Bulletin No: B102CRM157-0
Release Date: April 2, 2008
Effective Date: April 2, 2008
Supersedes: N/A
Completion Date: June 2, 2008
Page: 1 of 4

SERVICE BULLETIN

Ride Name: C.P. HUNTINGTON

Air Compressor Bracket Rework

Air compressor bracket

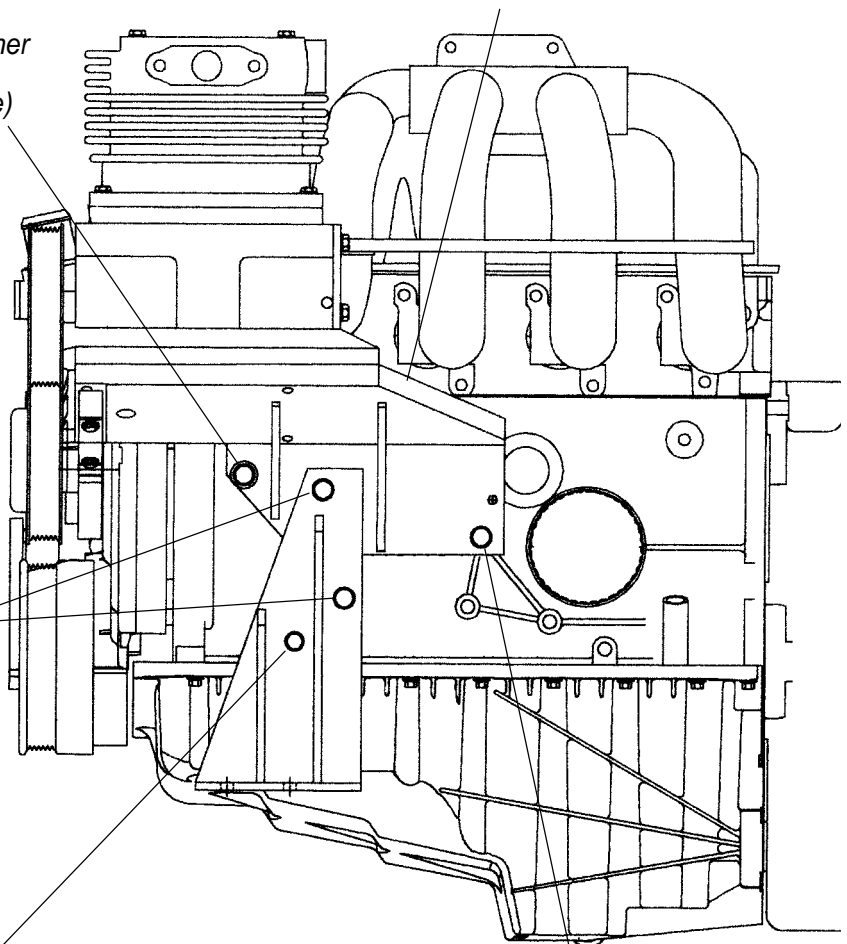
*M10-1.5 x 35mm capscrew
with 10mm special locking washer
at this location
(See Detail View on next page)*

*M10-1.5 x 40mm capscrew
with special locking washers
at these locations
See Detail View on next page*

*M8-1.25 x 40mm capscrew
with 5/16 special locking washer
at this location
(See Detail View on next page)*

*M10-1.5 x 92mm stud
with 10mm special locking washers
at this location
(See Detail View on next page)*

1. Remove the old fasteners one at a time and replace with the fasteners exactly as shown in the following illustration. Discard the old fasteners - DO NOT RE-USE.

2. As each fastener is installed, tighten it to the torque specifications shown on page 4.
3. Use a torque wrench to check the tightness of these fasteners monthly.

**Installation Detail of
LOCKING WASHER SET
Installed Under Head of Capscrew**

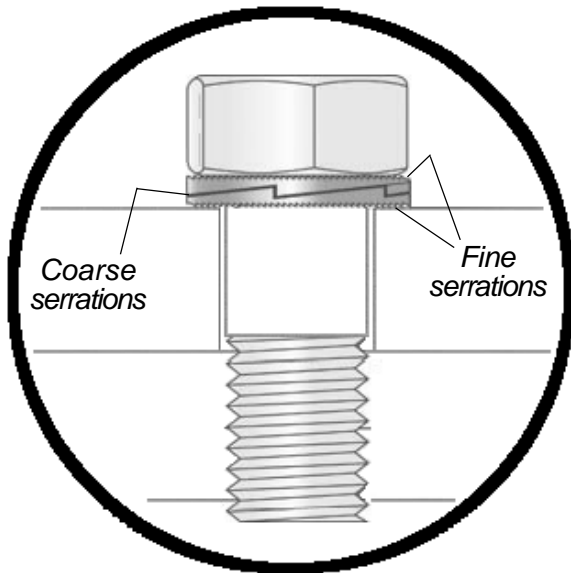
These washers must be installed in pairs. Make sure the coarse serrations of the two washers are mated with each other as shown. The fine serrations must be against the capscrew head and the mounted component. Tighten the capscrews as follows:

- 8mm capscrews - 19 ft-lbs (dry)
- 10mm capscrews - 37 ft-lbs (dry)

**Installation Detail of
LOCKING WASHER SET
Installed Under Nut on Stud**

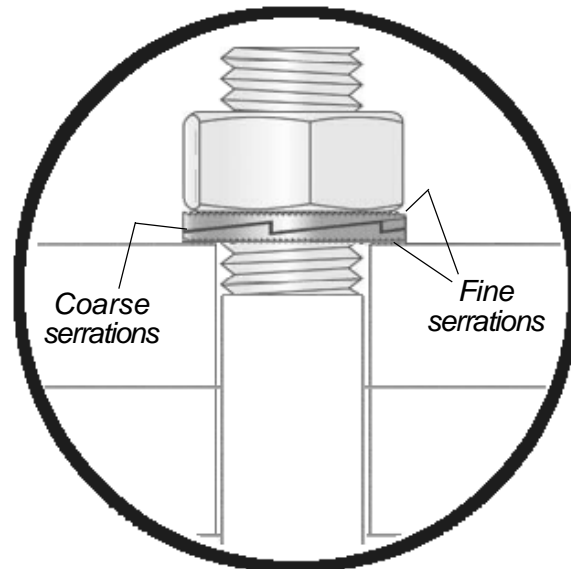
These washers must be installed in pairs. Make sure the coarse serrations of the two washers are mated with each other as shown. The fine serrations must be against the nut and the mounted component. Tighten the nuts as follows:

- 10mm nuts - 37 ft-lbs (dry)
